July 13, 1984

Subject: Request for Additional Information
Masonry Wall Design, I.E. Bulletin 80-11
R.E. Ginna Nuclear Power Plant

REQUEST FOR ADDITIONAL INFORMATION
MASONRY WALL DESIGN, IE BULLETIN 80-11
R. E. GINNA NUCLEAR POWER PLANT
DOCKET NO. 50-244
STRUCTURAL AND GEOTECHNICAL ENGINEERING BRANCH
STRUCTURAL ENGINEERING SECTION A

FINITE ELEMENT COMPUTER MODEL

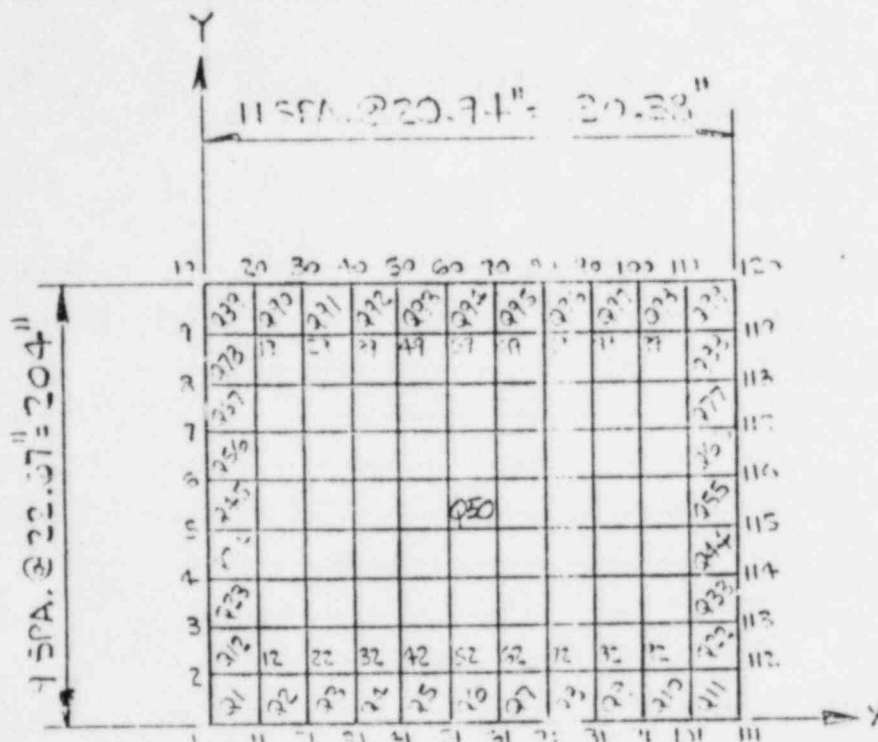
THE FOLLOWING EXAMPLE ILLUSTRATES THE CALCULATIONAL PROCEDURE USED IN THE POST PROCESSOR. WALL 2-IT IS CHOSEN AS A SAMPLE WALL. CHECK STRESSES IN ELEMENT 50 IN THE CENTER OF THE WALL. (SEE FOLLOWING PAGE FOR FINITE ELEMENT MODEL)

STRESS CHECK LEVEL 1

FROM "INTERIM CRITERIA FOR SAFETY-RELATED MASONRY WALL EVALUATION", APPENDIX A TO SRP SECTION 2.8.4, USNRC, REV. 0, JULY 1981, INCREASE FACTORS ARE 2.5 FOR AXIAL OR FLEXURAL COMPRESSION, 1.3 FOR TENSION NORMAL TO THE BED JOINT, AND 1.5 FOR TENSION PARALLEL TO THE BED JOINT, FOR LOAD COMBINATIONS INCLUDING SSE LOADS.

SAMPLE CALCULATIONS FOR QUESTION #16

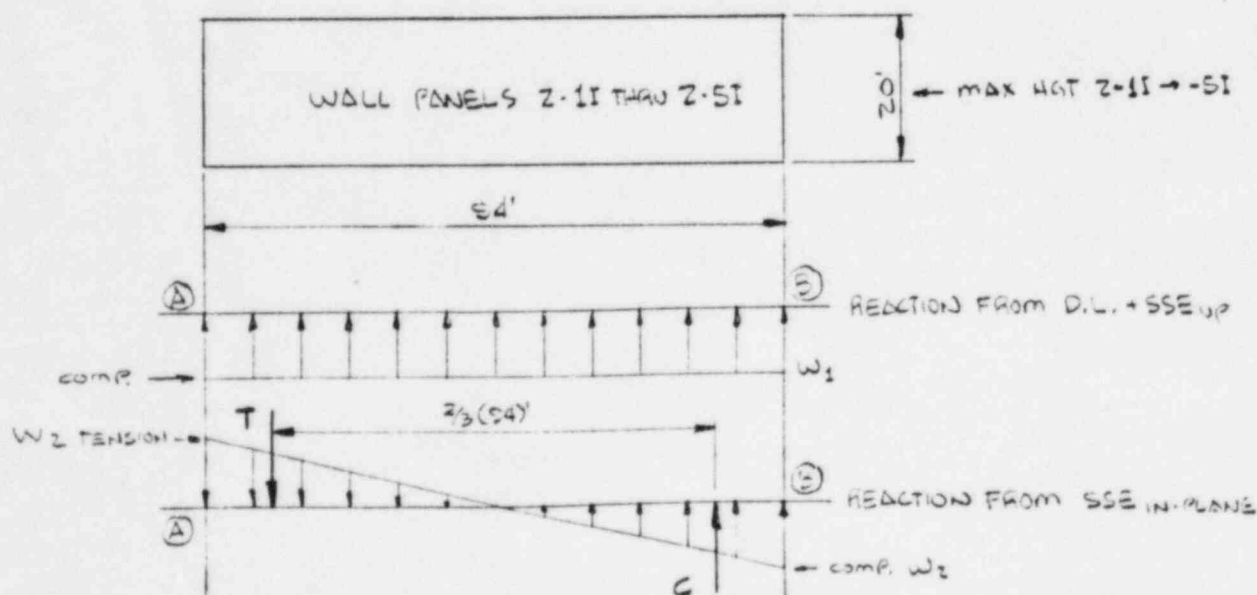
16. Explain how earthquake motions in three directions are treated in the analysis. Indicate whether any walls are subject to in-plane loading. If so, provide a sample calculation illustrating how the wall is qualified with respect to the SGEB criteria.

OBJECTIVE: CALCULATE STRESSES FROM IN-PLANE HORIZONTAL COMBINED WITH VERTICAL SSE LOADS FOR WALL PANEL Z-1I, AND DETERMINE IF STRESSES ARE WITHIN ALLOWABLE LIMITS.

WALL PANEL Z-1I IS SHOWN ON GAI DRAWING SS-581-443. THIS WALL PANEL IS PART OF A CONTINUOUS WALL MADE UP OF PANELS Z-1I THRU Z-5I. THE TOTAL LENGTH OF THIS CONTINUOUS WALL IS APPROXIMATELY 84'.

WALL ACCEPTABLE FOR USE IN-PLANE + VERTICAL LOADS
